SUBJECT: WATERFORD STEAM ELECTRIC STATION, UNIT 3 - ISSUANCE OF
AMENDMENT RE: MODIFY TS 5.6, "FUEL STORAGE"; ADD NEW
TS 3/4.9.12, "SPENT FUEL POOL BORON CONCENTRATION," AND
TS 3/4.9.13, "SPENT FUEL STORAGE" (TAC NO. MD9685)

Amendment No. 223
License No. NPF-38

SAFETY EVALUATION BY THE OFFICE OF NUCLEAR REACTOR REGULATION

Figure 5.6-1 Alternative Checkerboard Storage Arrangements

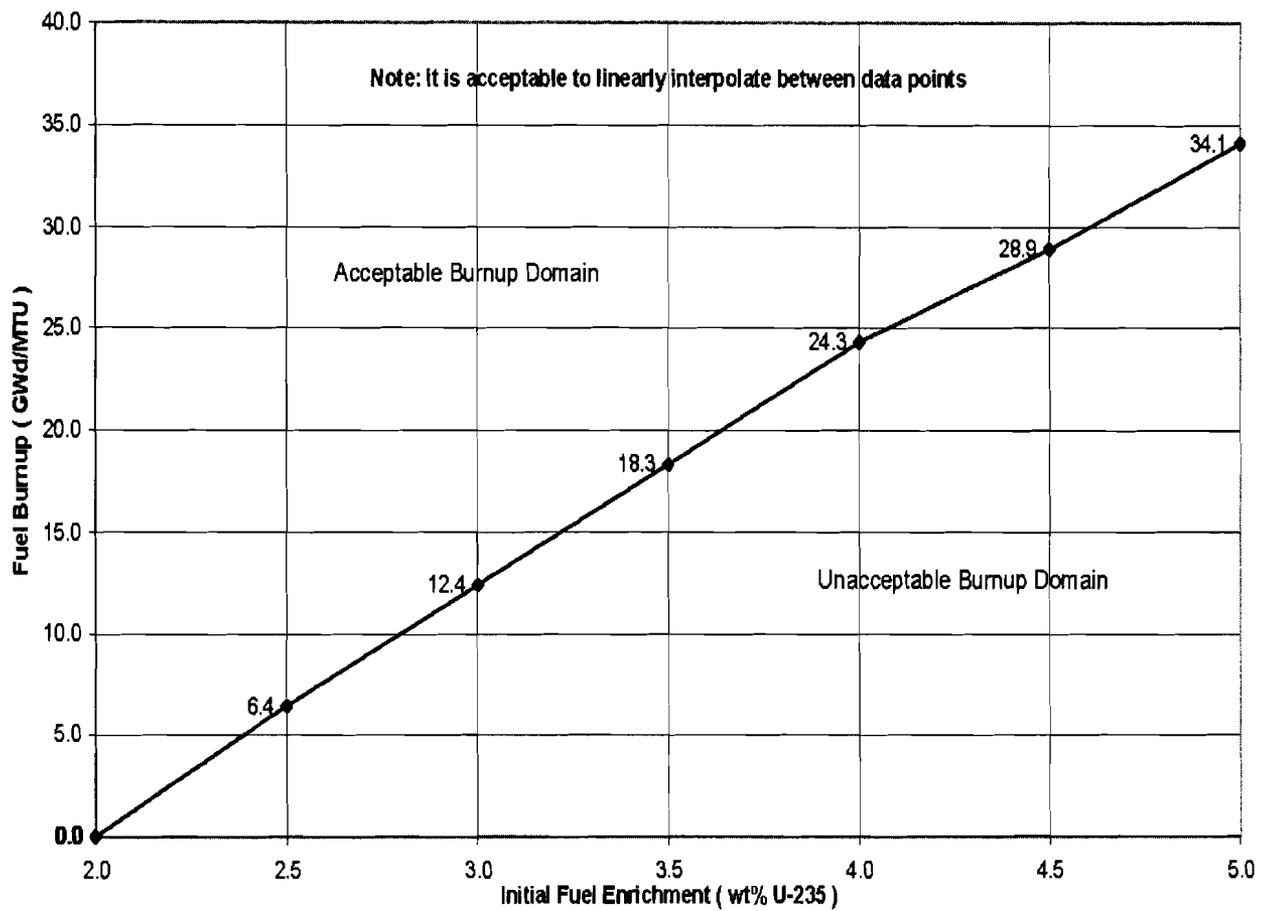
7. TS Figure 5.6-1 will be replaced by a new Figure 5.6-1 to show the new Alternative Checkerboard Storage Arrangements.

Fresh fuel assemblies may be stored in the Region 2 racks provided that they are stored in a "checkerboard pattern" with empty cells as illustrated in Figure 5.6-1, Pattern 1. Irradiated fuel assemblies with any burnup may also be stored with empty cells in the checkerboard configuration of Figure 5.6-1, Pattern 1.

Irradiated fuel assemblies with a burnup of ≥ 27 GWd/MTU [gigawatt days per metric ton unit] in the "unacceptable range" of Figure 5.6-2 may be stored in the Region 2 racks in a "checkerboard pattern," as illustrated in Figure 5.6-1, Pattern 2 with irradiated fuel in the "acceptable range" of Figure 5.6-3.

Figure 5.6-2 Acceptable Burnup Domain for Unrestricted Storage of Irradiated Fuel in Region 2 of the Spent Fuel Pool

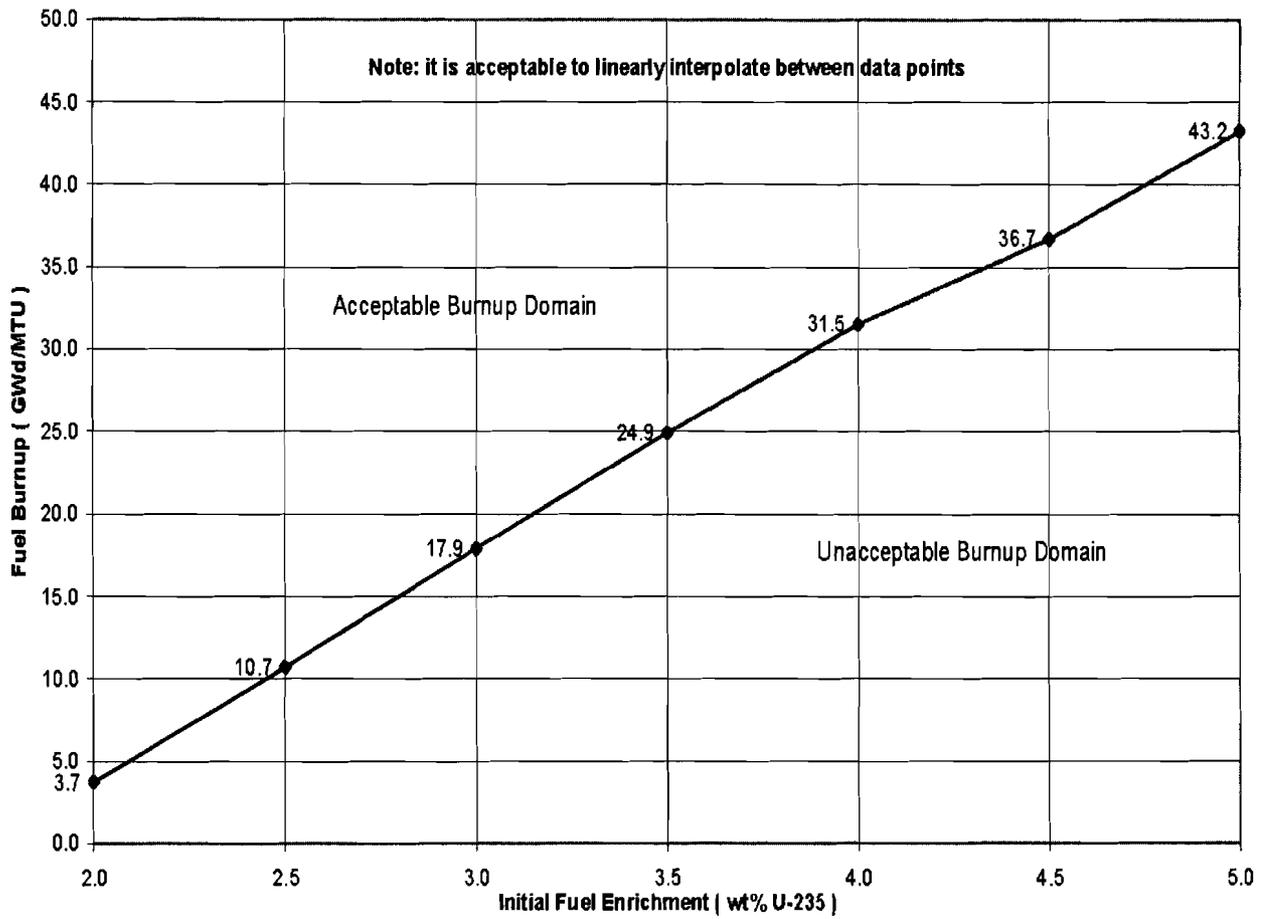
8. TS Figure 5.6-2 will be replaced by a new Figure 5.6-2 to show the new Acceptable Burnup Domain for Unrestricted Storage of Irradiated Fuel in Region 2 of the Spent Fuel Pool.

Irradiated fuel assemblies with a burnup in the "acceptable range" of Figure 5.6-2 may be allowed unrestricted storage in the Region 2 racks.

Figure 5.6-3 Acceptable Burnup Domain for Irradiated Fuel in a Checkerboard Arrangement with Fuel of 5 wt% Enrichment, or Less, at 27 GWd/MTU Burnup, or Higher, in Region 2 of the Spent Fuel Pool

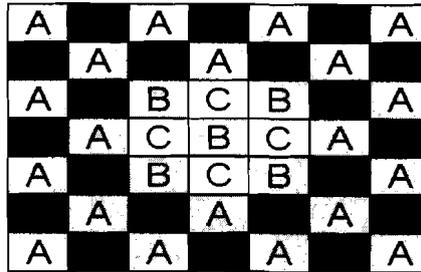
9. TS Figure 5.6-3 will be replaced by a new Figure 5.6-3 to show the Acceptable Burnup Domain for Irradiated Fuel in a Checkerboard Arrangement with Fuel of 5 wt % [weight percent] Enrichment, or less, at 27 GWd/MTU Burnup, or higher, in Region 2 of the Spent Fuel Pool.

Figure 5.6-4 Examples of Contiguous Checkerboard Configurations Which Meet Interface Requirements

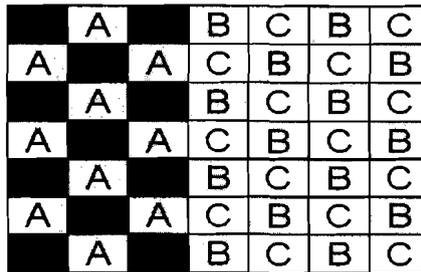
10. A new TS Figure, TS Figure 5.6-4, will be added to show Examples of Contiguous Checkerboard Configurations Which Meet Interface Requirements.
